Service Bulletin

Bulletin No.: PI1350

Subject: Information on Electronic Power Steering (EPS) Calibrations for Steering Gear

Models: 2013-2014 Buick Encore
2012-2014 Chevrolet Sonic
2013-2014 Chevrolet Trax

4003990

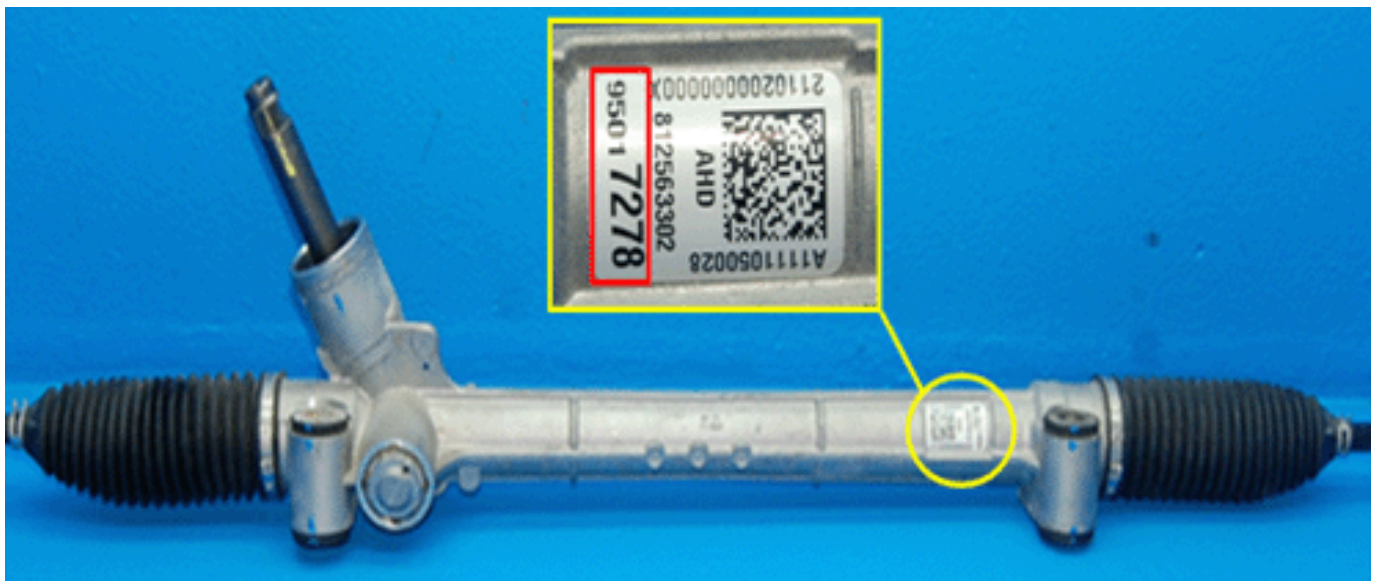
1. Lift the vehicle using a hoist and check the part number of the steering gear that is located on the area shown above.

Note: This steering gear part number will be used to define steering gear (old or new).
